ENCLOSURE 2 TO NL-13-028

Offsite Dose Calculation Manual Rev. 4

ENERGY NUCLEAR OPERATIONS, INC.
INDIAN POINT UNIT 1, 2, and 3 NUCLEAR POWER PLANTS
DOCKET Nos. 50-03, 50-247, and 50-286

OFFSITE DOSE CALCULATION MANUAL (ODCM)

Figure D 4.1-2 MAP DEFINING RELEASE POINTS

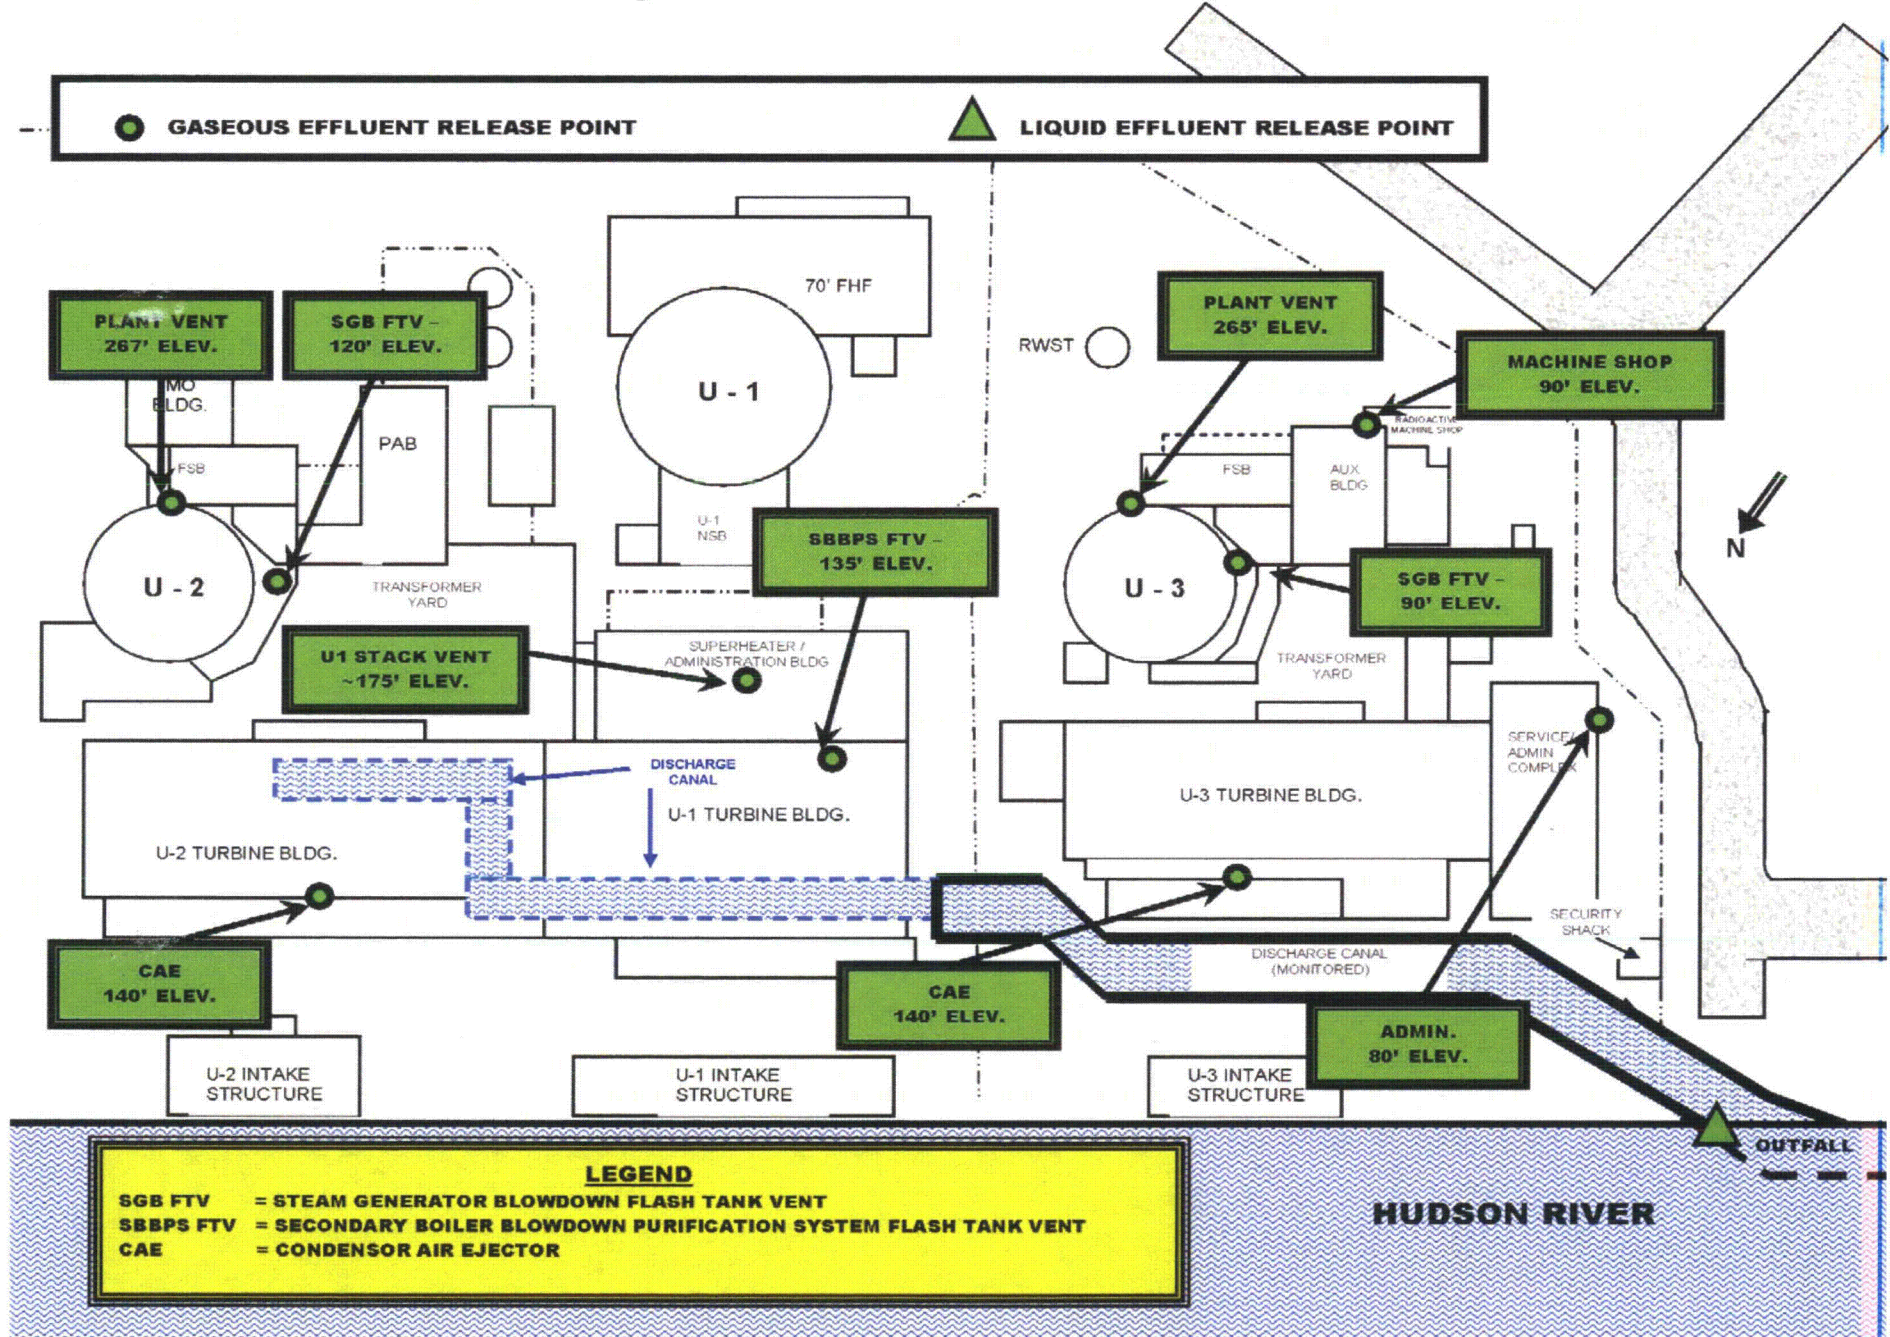
Modify Figure 4.1-2 to represent the new height of Unit 1 Stack release point.

Figure 4.1-2 was modified to show the release point height. While the stack is being partially removed, the release point was established early (out the side of the duct) at 175'.

The actual release point has been modified to just above the foundation to the stack, above the roof of the building. This elevation is higher than any other point in the area, and still meets the definition of 'mixed mode' while officially ground level releases. It was determined, therefore that Figure 4.1-2 should identify the height of the release point, and not confuse the reader with the height of the stack (either new or old).
